SERVICE BULLETIN

APPLICABILITY: 2017MY Legacy and Outback 2.5i Premium Models with EyeSight

NUMBER: 07-121-17

SUBJECT: DTC B2902

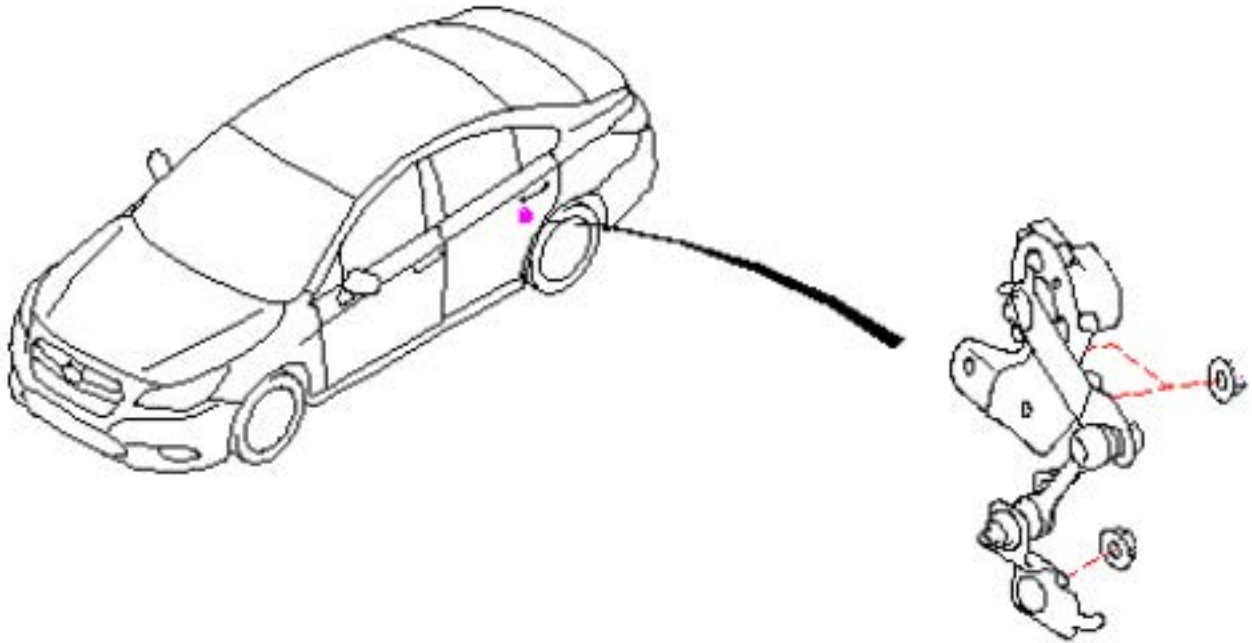
If DTC B2902 is stored in the Headlight Control System, confirm using the VIN and the Subaru Electronic Parts Catalog whether or not the vehicle should be equipped with the Headlamp Leveler sensor. If the vehicle is not equipped with the Headlamp Leveler Sensor, install the new (84051AL080) module. If equipped with the sensor, diagnose the DTC as per the applicable Service Manual.

The part number for the correct specification headlamp control module is **84051AL080**.
